**Transamerica
Delaval**

Subject: Standby Diesel Generators at
Nuclear Power Plants

NRC QUESTIONS

FIG. 1.2

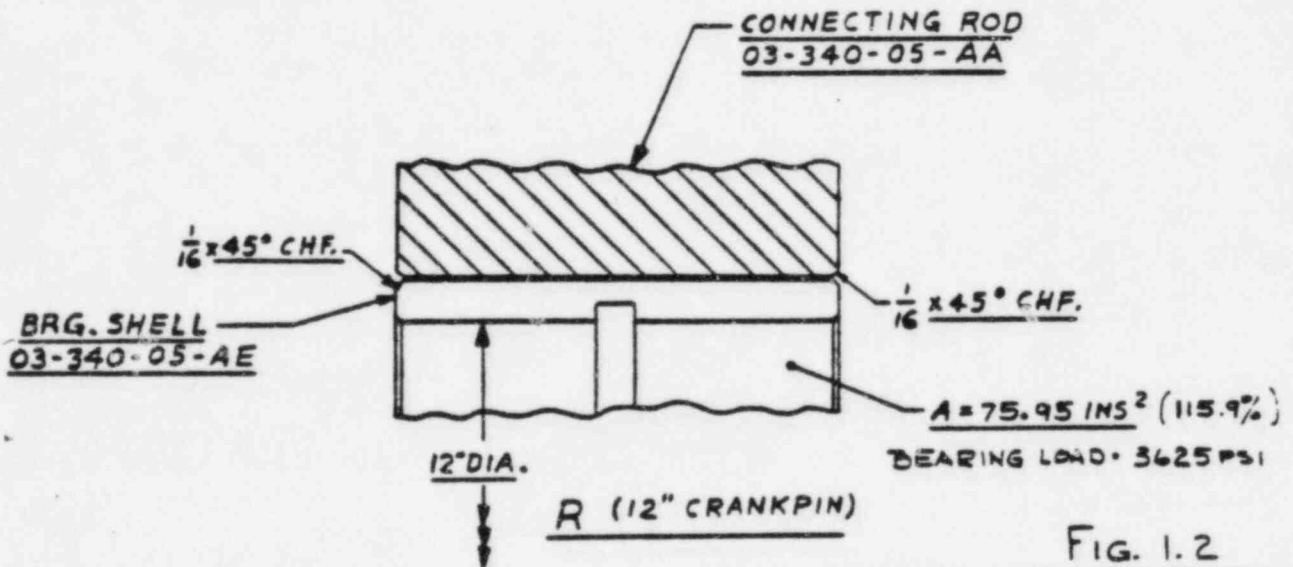
Q #8(b) - What action has TDI taken to ensure that new bearing will not fail in a similar fashion?

A #8(b) - In regard to LILCO and other R-48 engines installed in emergency standby service, the crankshaft is fitted with a connecting rod which has a smaller 1/16", chamfer on the edges. Figure 1.2 (attached) shows the bearing is fully supported. Even though there may be some porosity in the bearing shell material, the shell is in compression and therefore minor porosity would not be detrimental.

FIG. 1.3

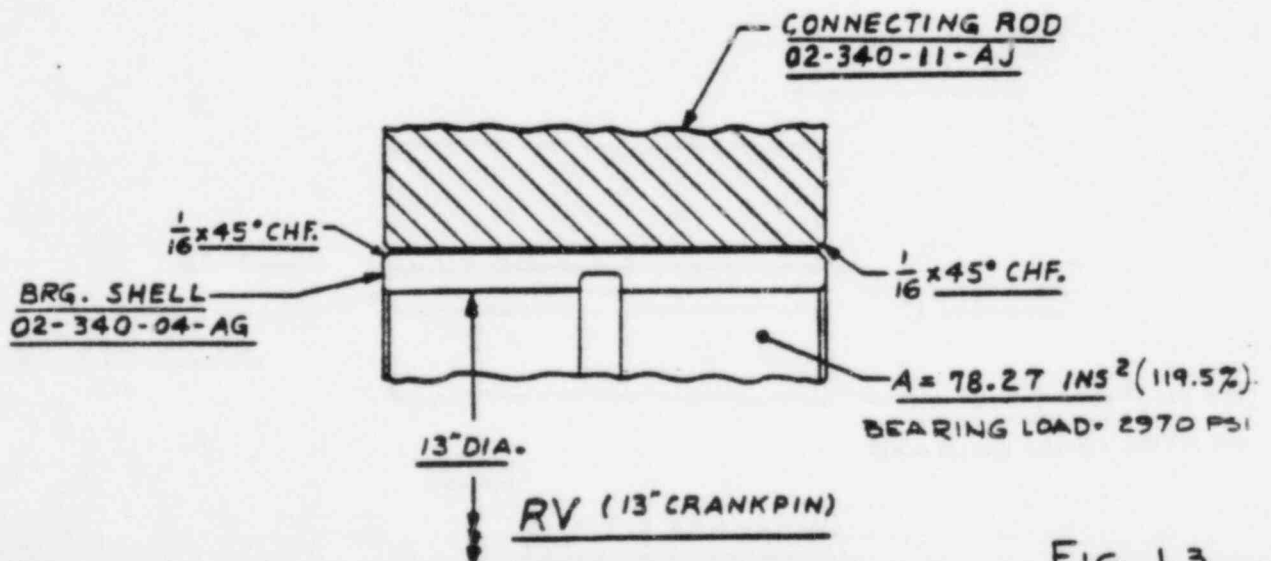
Q #8(d) - What action has TDI taken for other engines to preclude their failure in a similar fashion?

A #8(d) - The bearings in all other engines in nuclear service have connecting rod and bearing arrangements shown in Figure 1.2 and 1.3 (attached). Each provides full support for the bearing shell. The bearing shell is in compression, both from crush and operating forces, with no portion of the shell in tension. Therefore, if bearing material contains minor porosity, as all castings do, the loads present will not act with the stress intensifiers and result in cracks.
